#### **Addendum 78 – UN Regulation No. 79**

#### **Revision 5 - Amendment 3**

Supplement 3 to the 04 series of amendments – Date of entry into force: 4 January 2023

#### **Uniform provisions concerning the approval of vehicles with regard to steering equipment**

“5.6.4.8.2. Detection area on ground level

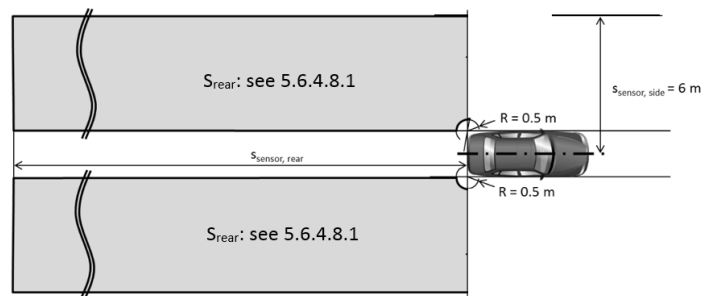
Paragraph 5.6.4.8.2., amend to read:

The vehicle system detection area on ground level shall be at minimum as shown in the figure below.”

2.1.2.1. General

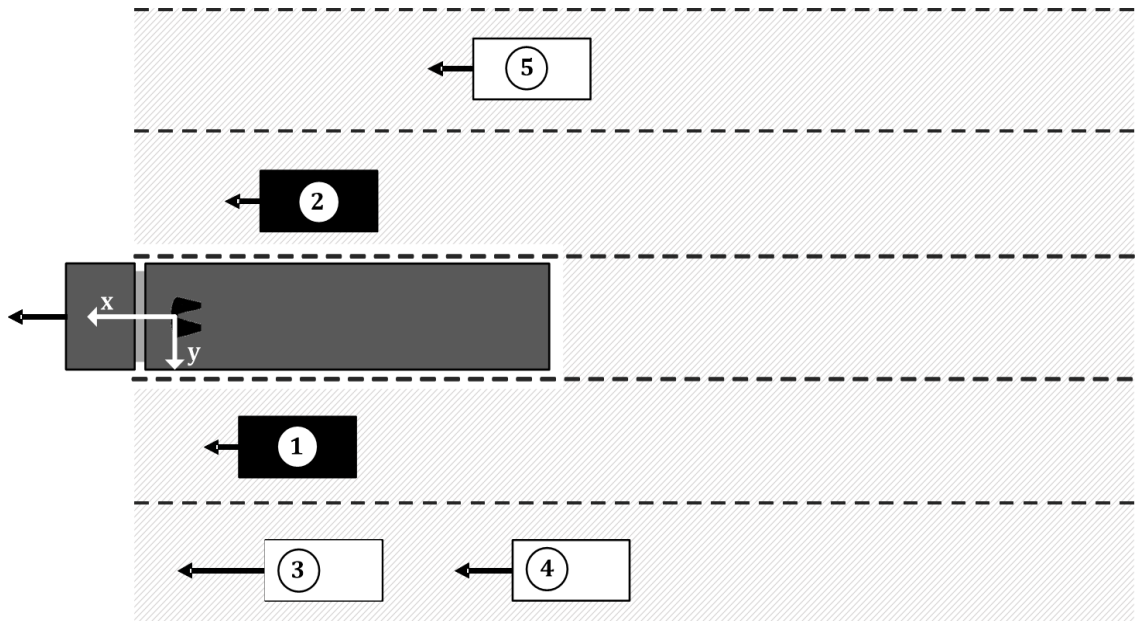
**IMPORTANT** — If ISO 11992-1 is used as a data link and physical layer only one trailer (towed vehicle) can be supported due to bandwidth overload of the CAN bus between towing and towed vehicles.

The towing vehicle shall not rely on any sorting of the objects communicated by the towed vehicle.

2.1.2.3. Objects behind the towed vehicle

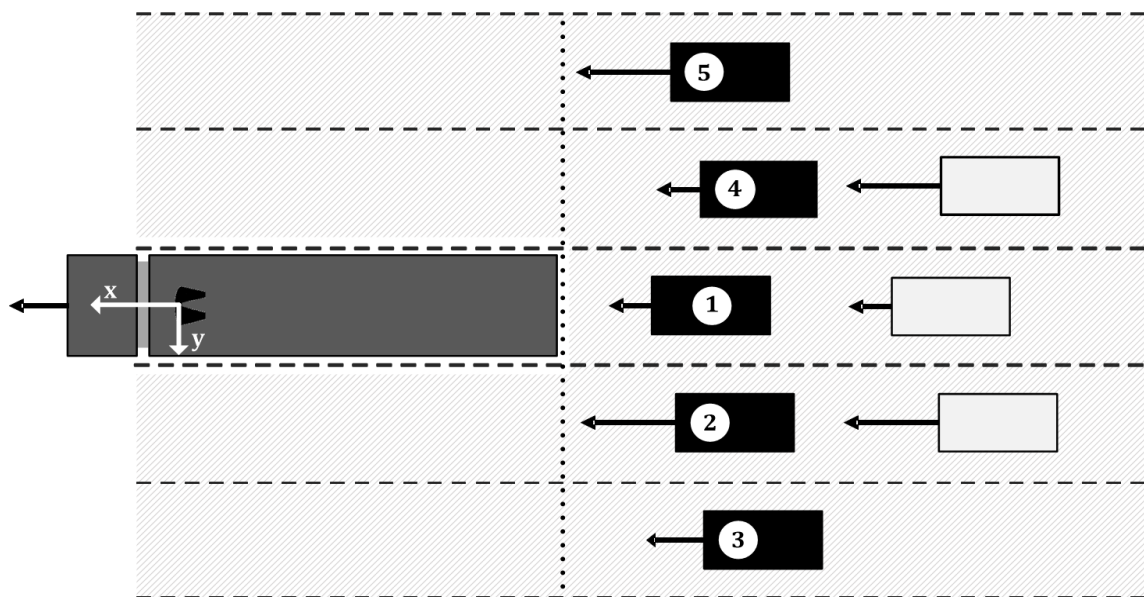
The area behind the towed vehicle is split into five ranges. From each range an object shall be selected, if present. If the absolute velocity of the towed vehicle > 10 km/h only moving objects shall be selected. An object is moving if its absolute velocity is not zero. The five ranges are specified by the lateral position relatively to the towed vehicle:

- (a)  $-0.5 \times w - 7 \text{ m} \leq y < -0.5 \times w - 3.5 \text{ m}$
- (b)  $-0.5 \times w - 3.5 \text{ m} \leq y < -0.5 \times w$
- (c) behind the towed vehicle
- (d)  $0.5 \times w < y \leq 0.5 \times w + 3.5 \text{ m}$
- (e)  $0.5 \times w + 3.5 \text{ m} < y \leq 0.5 \times w + 7 \text{ m}$

Where  $y$  is the lateral position [m] and  $w$  is the width [m] of the towed vehicle.
